| Project | IEEE 802.16 Broadband Wireless Access Working Group http://ieee802.org/16 > |
| Title | Comments on the Proposed Baseline Content on the Uplink Control Structure for the 802.16m SDD |
| Re: | IEEE C802.16m-08/725: Proposed Baseline Content on the Uplink Control Structure for the 802.16m SDD |
| Abstract | This provides a modified text in 11.x.2.5 Bandwidth Request Channel. |

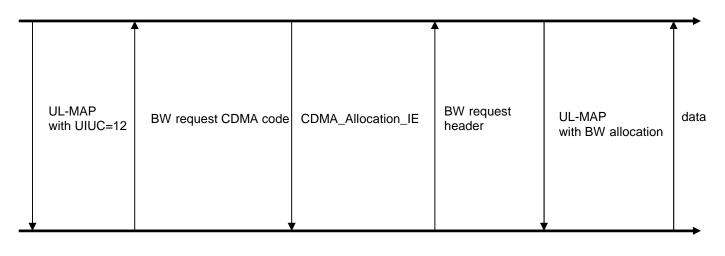
For delivering the data, if the MS uses contention-based bandwidth request mechanism described in 6.3.6.5 of IEEE 802.16e-2005 [1], normally five handshakes between BS and MS are required regardless of the QoS requirement associated with traffic requesting uplink bandwidth. Figure 1 describes the contention-based bandwidth allocation mechanism described in IEEE 802.16e-2005.

To support different levels of QoS, it is desirable that the contention-based bandwidth request channel provides a mechanism for prioritized bandwidth requests.

Contention based [or non-contention based] random access is used to transmit a bandwidth request indicator on this control channel. <u>To support different levels of QoS, bandwidth request channel provides a mechanism for prioritized bandwidth requests.</u> [Inclusion of additional information in a bandwidth request indicator such as bandwidth request size, MS-ID, flow identifier, UL transmit power report and CINR report is FFS.]
